# PD Modification Application PRS 22-0303

Request Minor Modification to PD

The applicant is requesting a Minor Modification to PD 20-0173 to allow the fence height increase from 6 feet to 15 feet for a fence along the PD northern boundary, adjacent to the railroad.

2.5 Proposed Site Plan

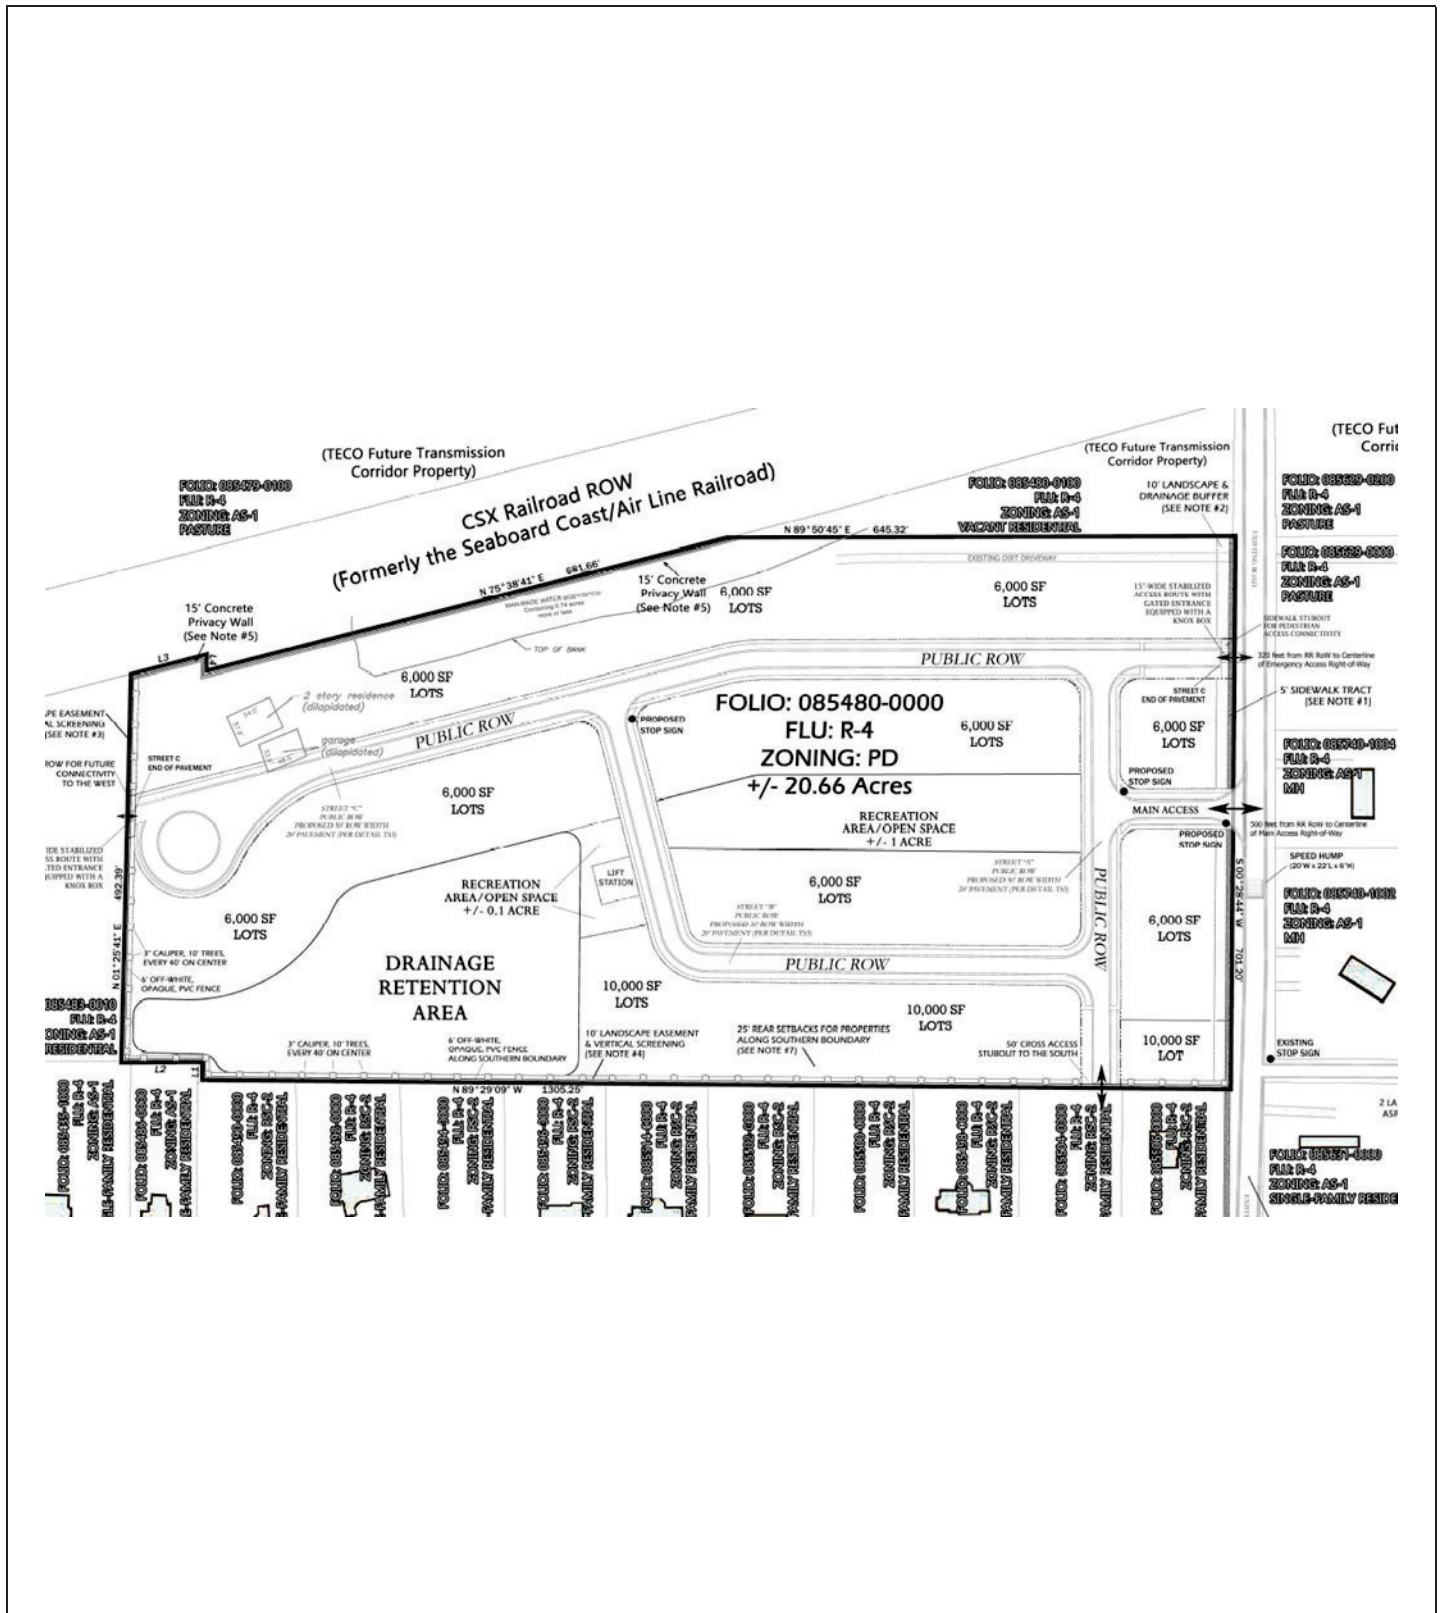
- 2.5 As depicted on the general site plan, a ~~six-foot high fence~~ 15-foot concrete privacy wall shall be provided along the north PD boundary adjacent to CSX Railway.
